SYDNEY WESTERN CITY PLANNING PANEL

COUNCIL ASSESSMENT REPORT

Panel Reference	2018SSW015
DA Number	DA-265/2018
Local Government Area	Liverpool City Council
Proposed Development	<p>Demolition of existing structures, subdivision into 3 lots, construction of an internal roads and construction of 3 residential flat buildings with basement parking.</p> <p>The proposal is identified as Nominated Integrated Development, requiring approval from the NSW DPI Water pursuant to the Water Management Act 2000.</p> <p>Liverpool City Council is the consent authority and the Sydney Western City Planning Panel has the function of determining the application.</p>
Street Address	190 Croatia Avenue Edmondson Park
Applicant	Croatia 88 Pty Ltd
Owner	Croatia 88 Pty Ltd
Date of DA Lodgement	4 April 2018
Number of Submissions	Two (2)
Regional Development Criteria (Schedule 4A of the Act)	The development has a capital investment value of \$36,550,000.00
List of All Relevant 4.15(1)(a) Matters	<ul style="list-style-type: none"> • <i>List all of the relevant environmental planning instruments: Section 4.15(1)(a)(i)</i> • State Environmental Planning Policy No.65 – Design Quality of Residential Apartment Devel

Figure 5: Modified Design – Articulated Balconies

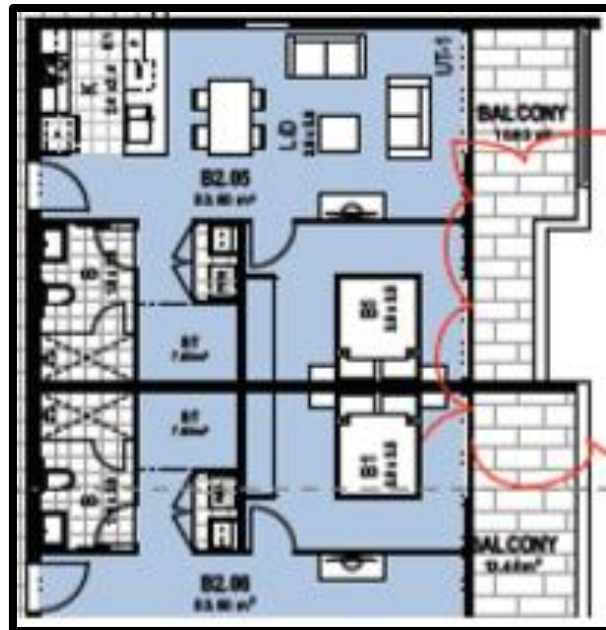
The Panel recommends redesigning the balconies, so that they work better, both spatially and visually. The long and narrow shaped balconies in the current design are not readily useable and provide limited articulation to the building facade. The panel recommends either redistributing the spaces within the apartments, in order to increase the size and shape of balconies or reducing the width of the balconies to create “outdoor spaces” (rather than balconies) that are integrated with the internal spaces. This will facilitate enhanced articulation of the built form of the building.

Comment: The applicant has reviewed the advice of the DEP with regards to the balcony design and have incorporated the following changes;

- The balconies for Buildings A, B and C have been amended to reduce their width and create “outdoor spaces” that are integrated with the internal spaces.
- A break has been provided to the balconies for the smaller units (1 Bedroom). The intention of the amendment is to allow for better articulation

of the facade and improves the visual amenity of the buildings when viewed from the adjoining streets as recommended by the DEP. The design also creates outdoor spaces that were encouraged by the Panel, rather than long narrow continuous balconies as originally proposed. The modified balcony designs are illustrated in the figures below;

Figure 11 Building Separation Level 5

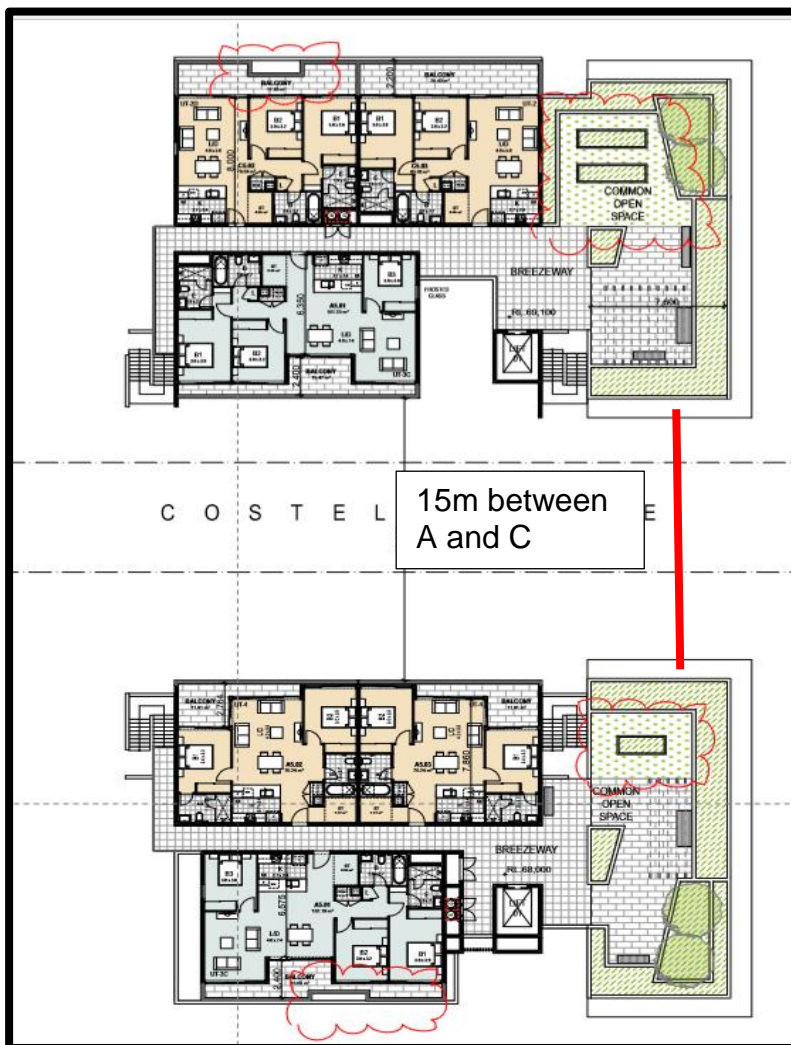
- A separation of 15.4m is provided between buildings A and C across Costello Lane which does not comply, as shown in figure below.

The variation to section 2F is worthy of support in this instance for the following reasons;
